Ducted Systems Technical Services Service Letter

Letter: **YSR-002-24**

Subject: **Outdoor ECM fan motor failures – Wolong brand**

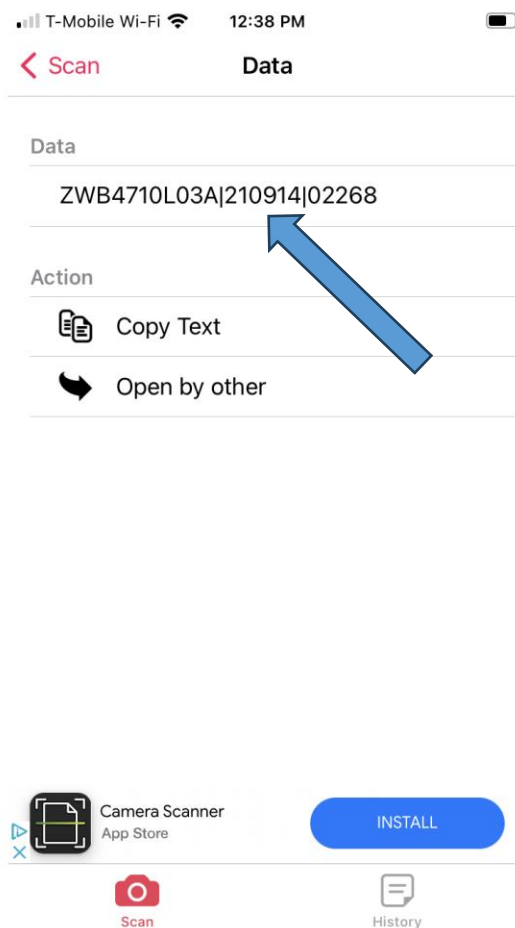
There was a continuous improvement effort implemented into Wolong ECM motor production on September 13th, 2022. The improvement is an O-ring seal between the end cap and motor case. The photo to the right shows the O-ring inside the motor case. The improvement was announced on May 9th, 2023, in service letter ST-013-23. The service motor part number is S1-02440880000, and part number did not change when the O-ring improvement was made. Replacement motors with the O-ring improvement arrived at Source 1 on 11/09/2022 and material shipped after that date contain the O-ring improvement. The factory part number of the motor is 5900093 and, just like the service part, the part number did not change when the O-ring improvement was made. Due to this fact, we cannot provide a serial number range of equipment containing motors with the O-ring seal. The only way to identify this is by motor date code.
